ADDENDUM 1

DATE: March 29, 2024

IFB 13-24
Rockville Swim & Fitness Center Outdoor Recreation
Pool Renovations Project

1 UTILITY PLAN
SCALE: 1" = 30'

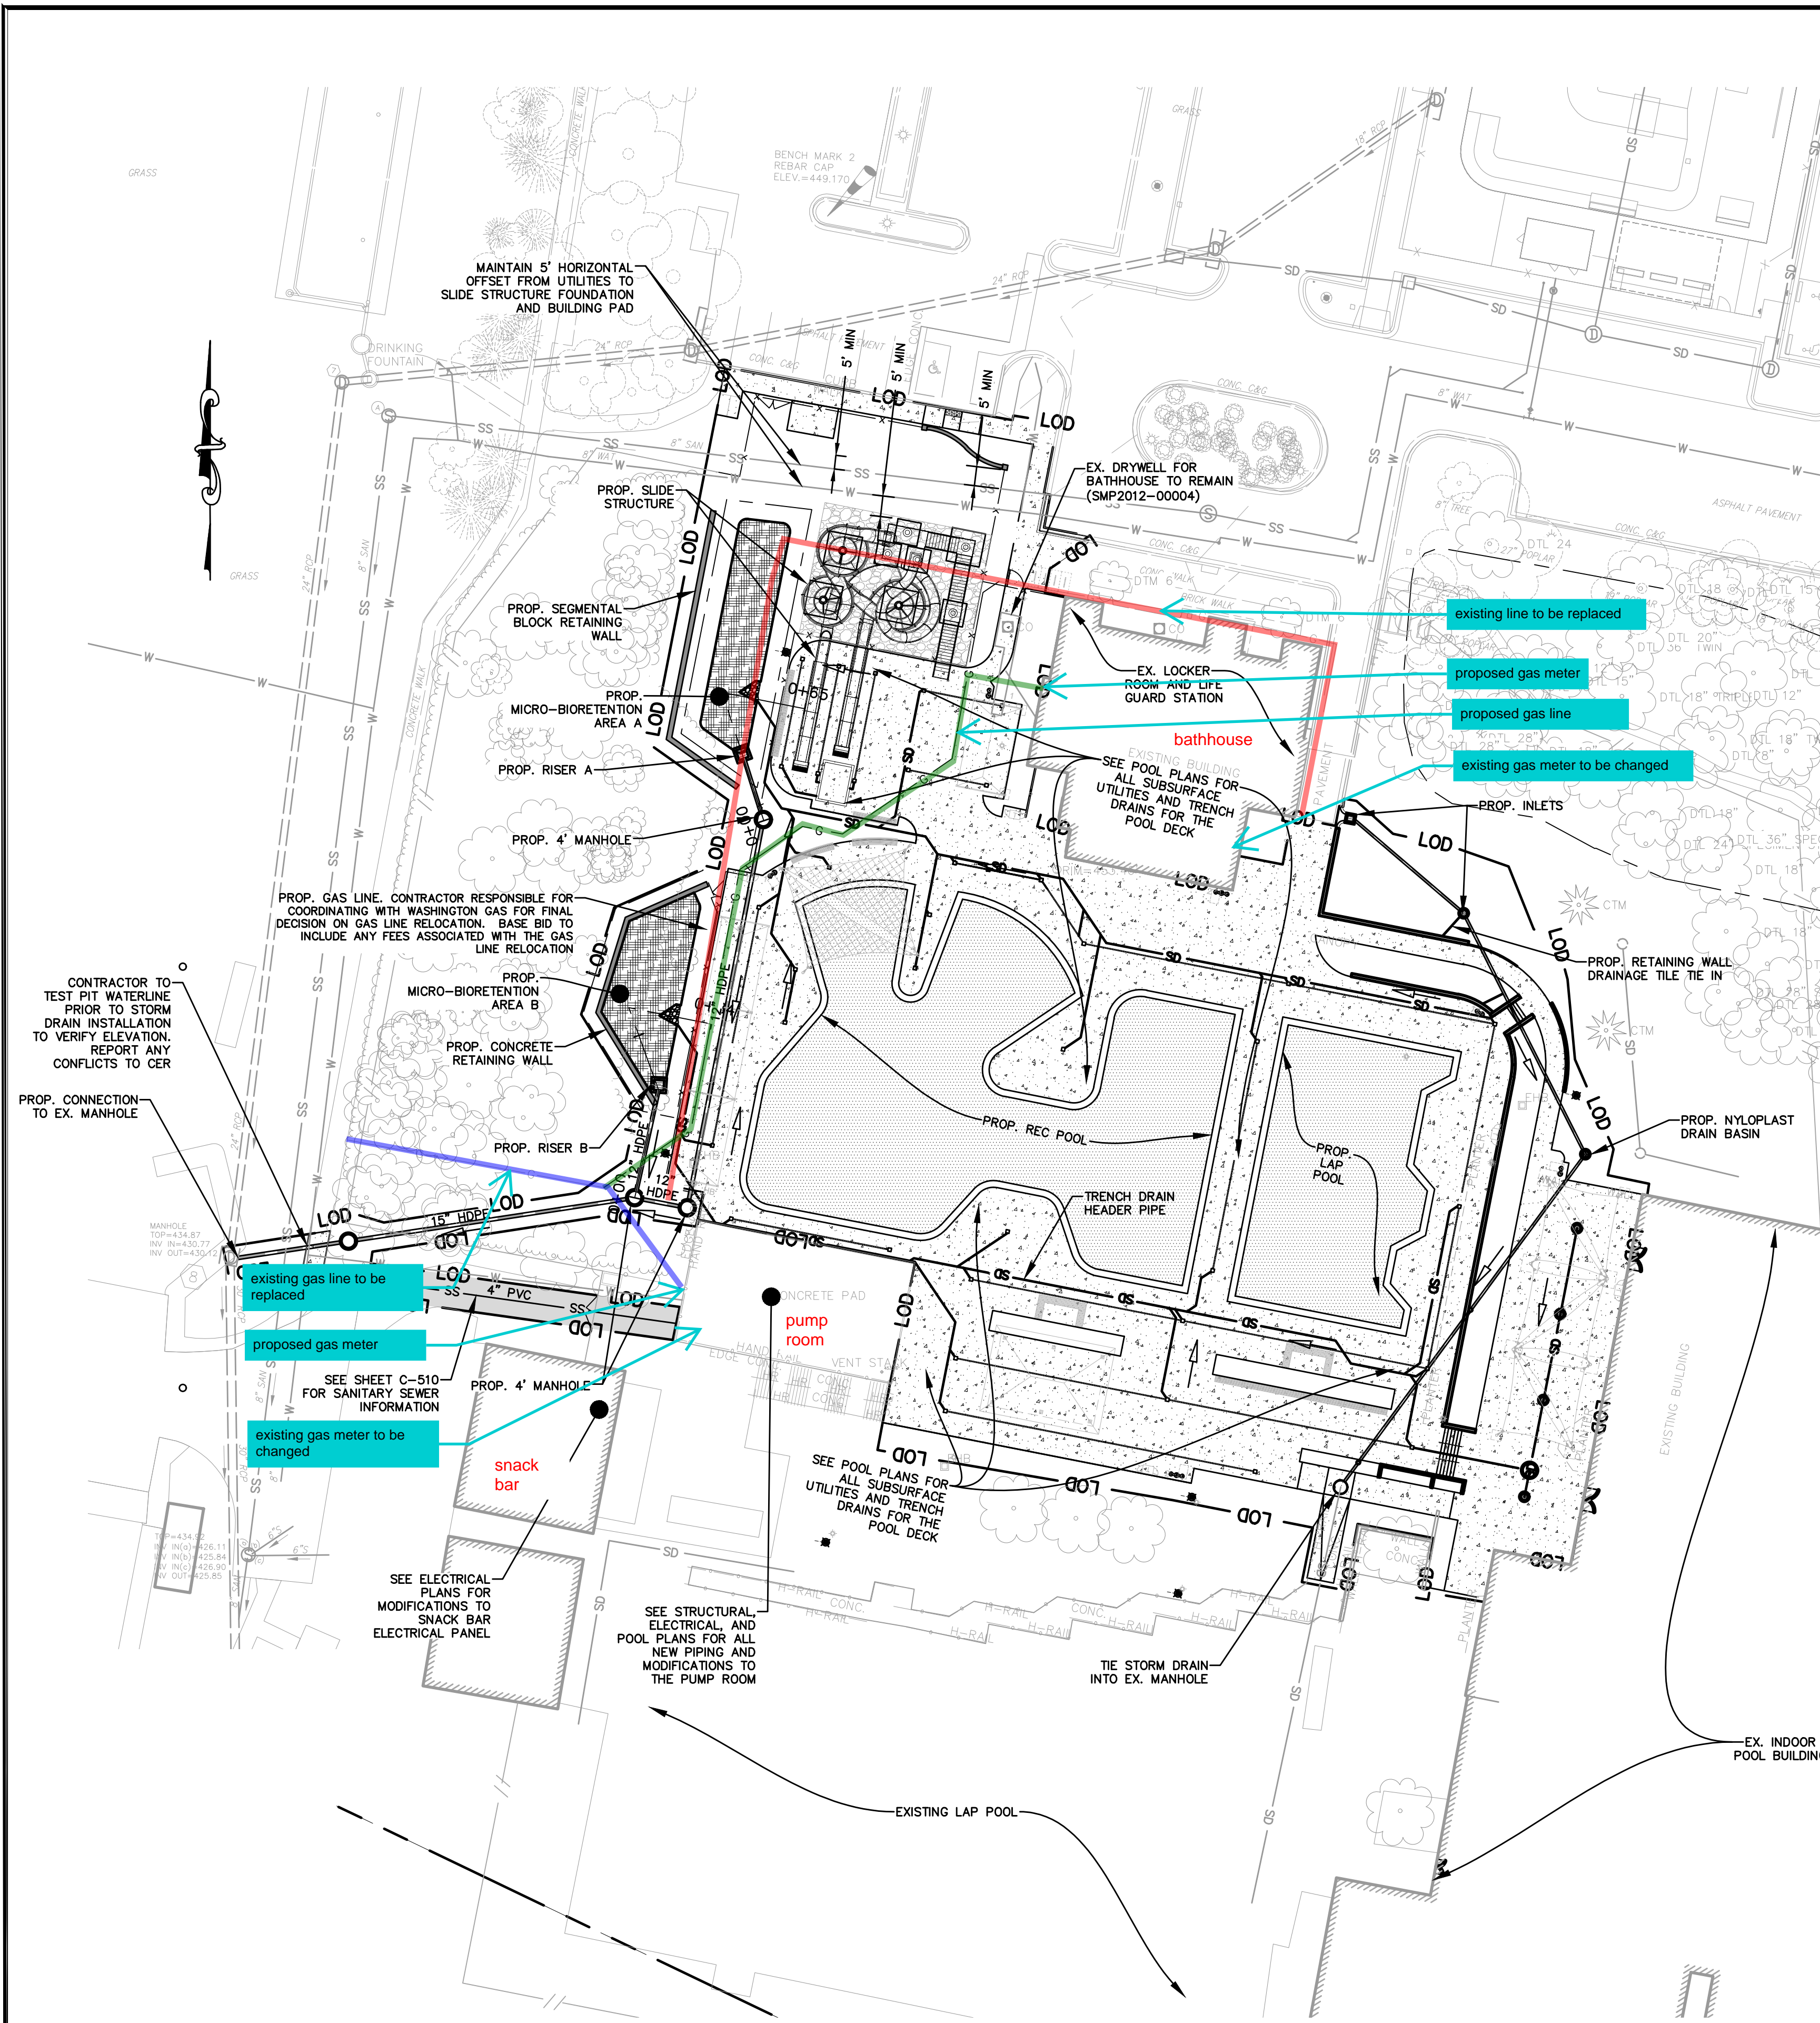
Sheet C-500 shows the proposed relocation of the existing gas line to accommodate the proposed slide tower. This work will also require the relocation of two gas meters to outdoor locations. City of Rockville and the Architect’s team have started coordination with Washington Gas about the relocation of the gas line. The relocation work must be performed by Washington Gas’s approved third-party contractor, NPL, but the costs of the work will be apportioned between Washington Gas and the City of Rockville accordingly. The contractor is responsible for including a \$60,000 allowance in their bid for this work. The allowance is intended to cover the portion of NPL’s scope that is the City’s responsibility, as well as work not performed by Washington Gas or NPL, such as placement of the new meters, new concrete pads for the meters, and all associated piping from the meters to appliances. See [Attachment C](#) for the schematic showing the proposed locations of gas lines and meters and [Attachment D](#), which is a revised to include a line item for this allowance.
